## Service Bulletin

SB08-53-01

ENGINE COWLING ALIGNMENT INSPECTION AND MODIFICATION

To provide a more detailed inspection of the engine cowling installation for alignment, fit, and clearance with the fuselage; and for cracks in the firewall. To provide modifications for the cowling shock mount attach brackets and engine baffle seals.

Figure 3. Nose Cap Alignment Fixture Installation (Sheet 1)

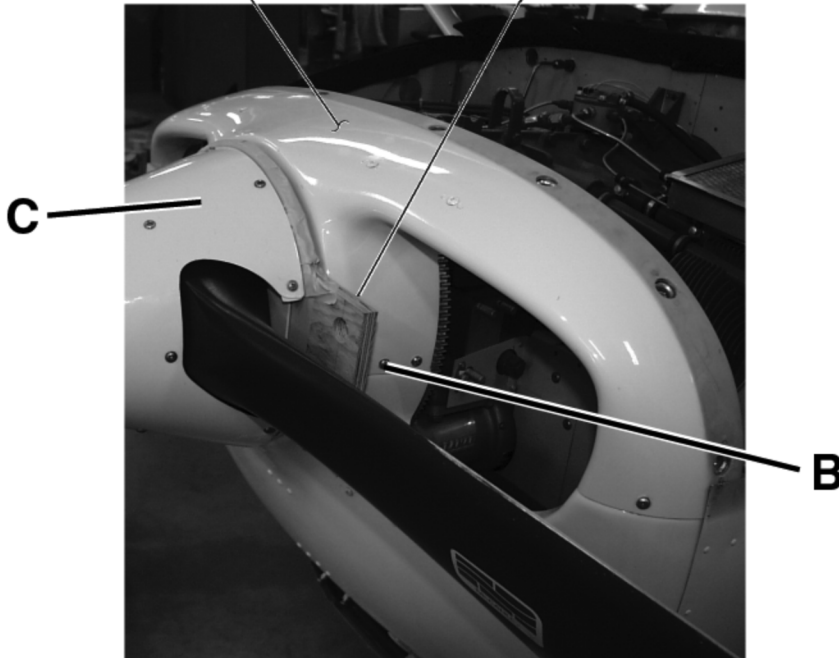
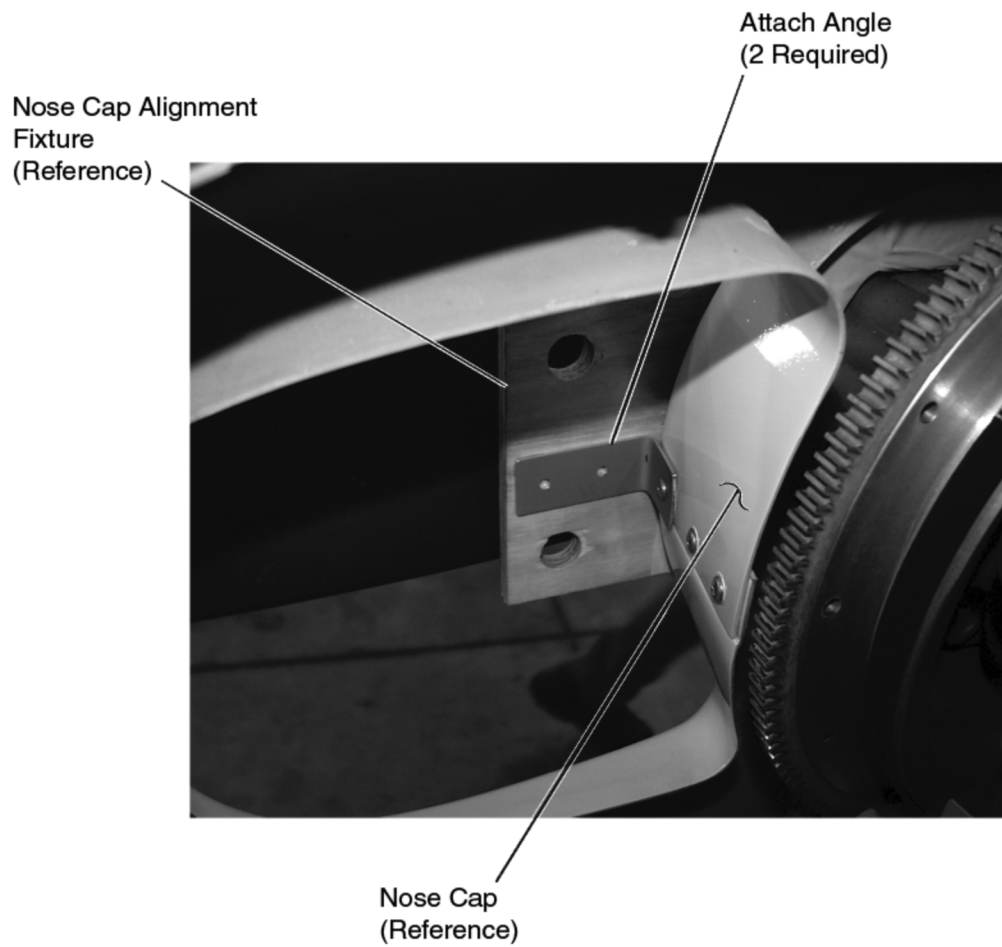
- C. (Refer to Figure 3, Detail A.) Position the propeller so that the blades are horizontal.

- (1) (Refer to Figure 3, Detail A and Detail C.) Install the nose cap alignment fixture between the propeller spinner aft bulkhead and the spinner boss on the nose cap assembly.

Figure 3. Nose Cap Alignment Fixture Installation (Sheet 2)

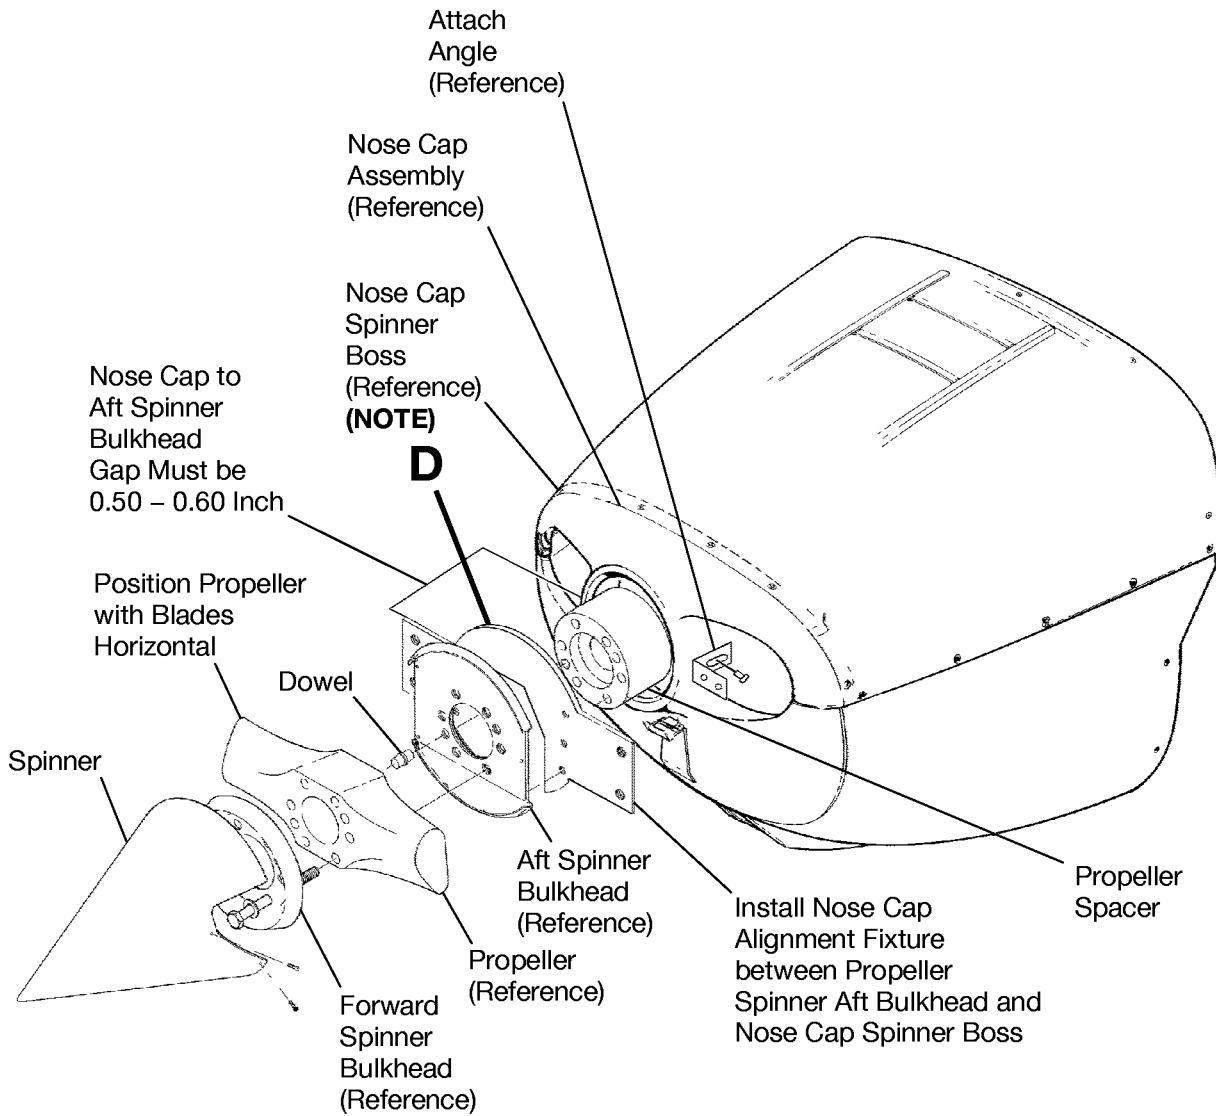
- (2) (Refer to Figure 3, Detail B.) Install one attach angle to the nose cap assembly on the inboard face of each of the (left and right hand) cooling air inlet openings. Use the AN528-832R8 Screw installed in the nose cap forward location and install it through the slotted hole in the flange of the attach angle.

Figure 3. Nose Cap Alignment Fixture Installation (Sheet 3)

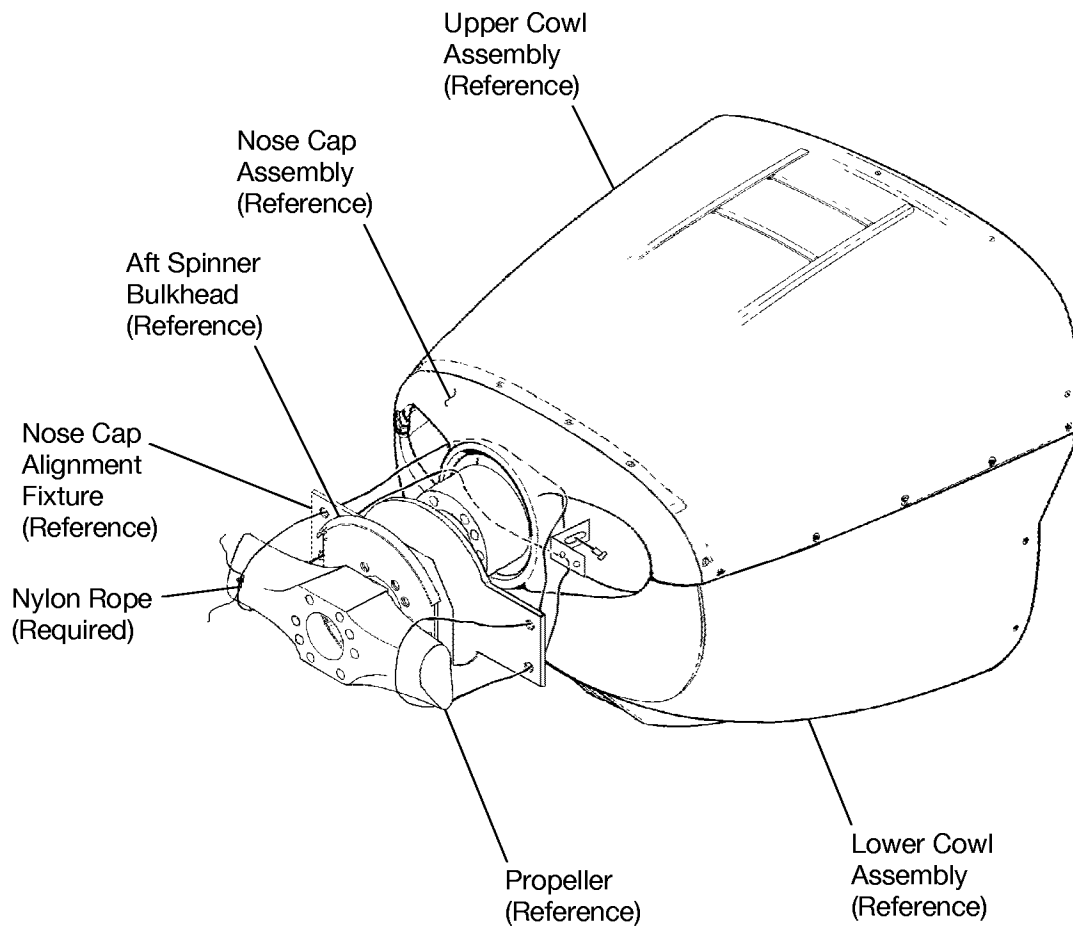
- (3) (Refer to Figure 3, Detail C.) Move the nose cap assembly to center the nose cap spinner boss on the propeller spacer.

**NOTE:** The propeller spacer must be centered in the nose cap spinner boss opening.

Figure 4. Cowling Alignment Fit and Clearance (Sheet 2)

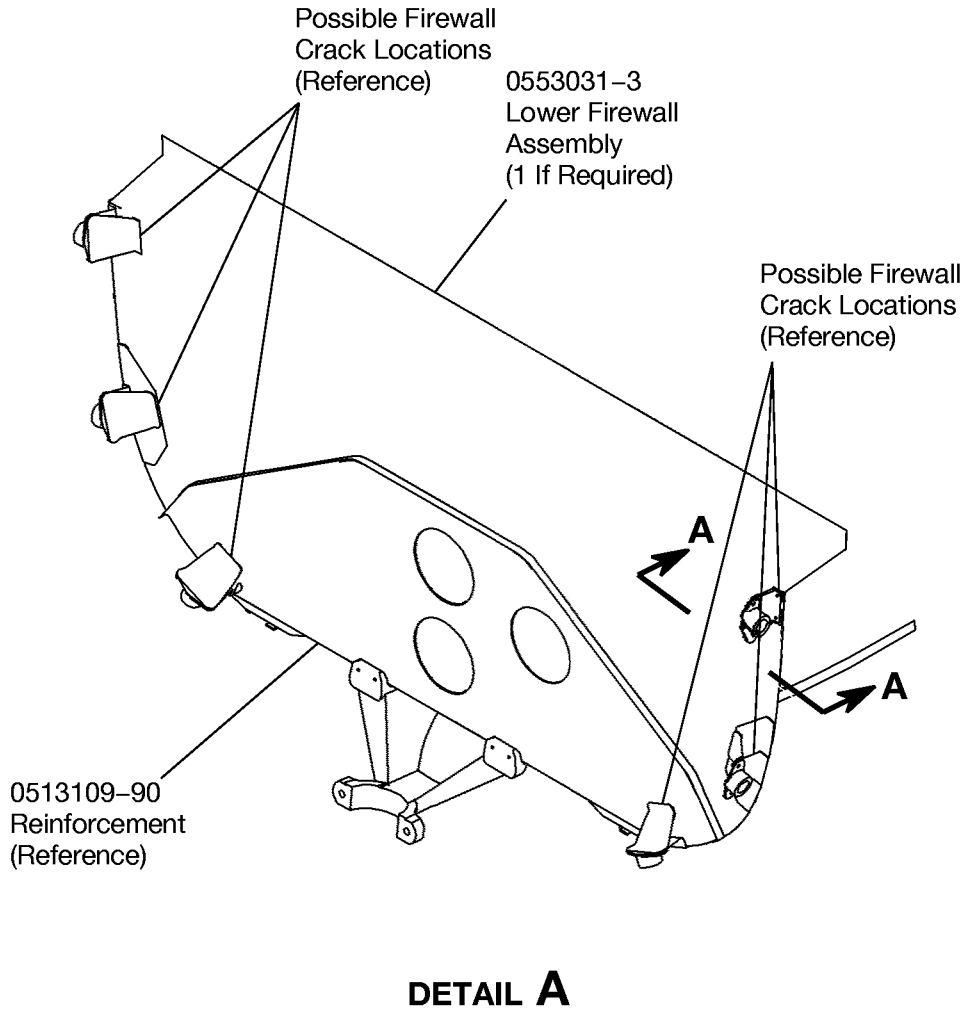
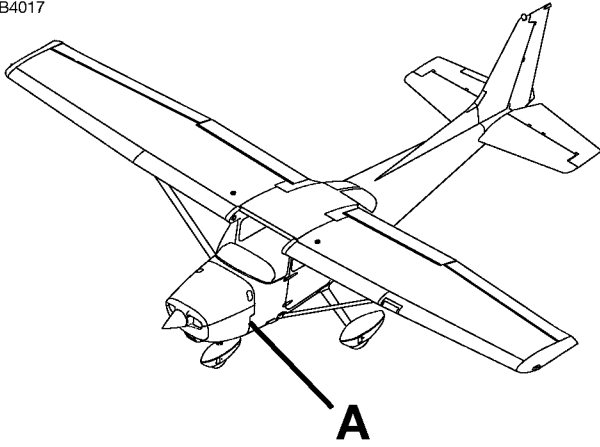
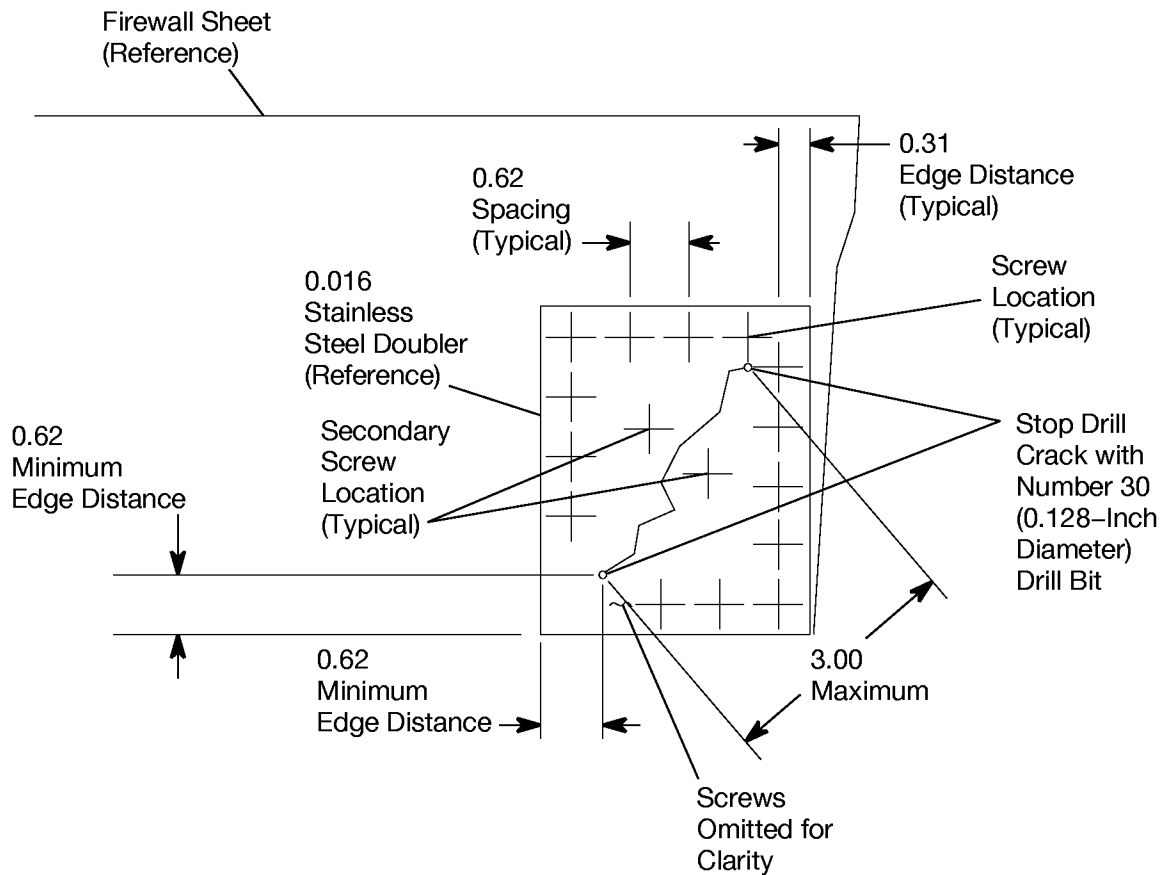
- (4) (Refer to Figure 4, View A-A.) If crack length is 3.00 inches or less:
- (a) Remove the pilot and copilot seats. (Refer to Model 172 Series 1996 And On Maintenance Manual, Chapter 25, Flight Compartment - Maintenance Practices.)
  - (b) Remove the pilot and/or copilot rudder pedal shields as necessary.
  - (c) Remove and keep carpeting and soundproofing material from the lower firewall as necessary to get access to lower firewall. (Refer to Model 172 Series 1996 And On Maintenance Manual, Chapter 25, Soundproofing and Insulation - Maintenance Practices.)

- (d) Stop drill crack(s) using a Number 30 (0.128 inch diameter) drill bit.
- (e) (Refer to Figure 4, View A-A.) Fabricate a doubler similar to the one shown, ensuring allowance for minimum edge distance spacing of screws. Doubler material is to be 0.016 inch 301 Annealed Stainless Steel (per MIL-S-5059 or equivalent) with 0.030 inch minimum bend radius when necessary. Acceptable alternate doubler materials are 302, 304, or 321 Annealed Stainless Steel sheet per AMS5516 or equivalent.

**NOTE:** (Refer to Figure 4, Detail A.) The doubler may be installed on the aft side of the firewall in areas where the 0513109-90 Reinforcement is installed on forward side of firewall.

- (k) Deburr holes in firewall and doubler.
  - (l) (Refer to Figure 4, View A-A.) If the mid section of the crack is more than 0.62 inch from the closest screw, use of a secondary screw location will be necessary.

(n) (Refer to Figure 4, View A-A.) Install the fabricated doubler to firewall assembly with MS35206-226 (MS35206-241 oversize) Screws and MS21042-06 (MS21042-08 oversize) Nuts as shown.
